## UNITED STATES PATENT AND TRADEMARK OFFICE

APPLICATION NO.	FILI	ING DATE	FIRST NAMED INVENTOR	ATTORNEY DOCKET NO.	CONFIRMATION NO	
09/764,936	01	/18/2001	Roland Eberlein	4965-000114	9936	
21874	7590	02/03/2004		EXAMINER		
EDWARDS		ELL, LLP	ODLAND, KATHRYN P			
P.O. BOX 55874 BOSTON, MA 02205				ART UNIT	PAPER NUMBER	
,				3743		
				DATE MAILED: 02/03/2004

#### **DETAILED ACTION**

# Appendux

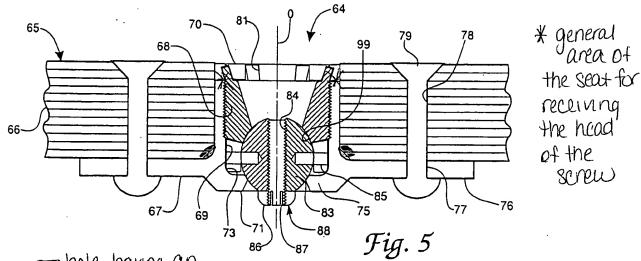
- a. Stoffer et al. fail to teach or suggest a hole having an inner surface that is formed about spherically curved. However, Stoffer et al. do have a hole having an inner surface that is formed about spherically curved. An Appendix has been provided showing the spherically curved portion in green.

However, again given the bushing is element 67, not element (83), there is a seat, shown in red in an Appendix that has been provided.

Inner surface that is formed about spherically, curved.
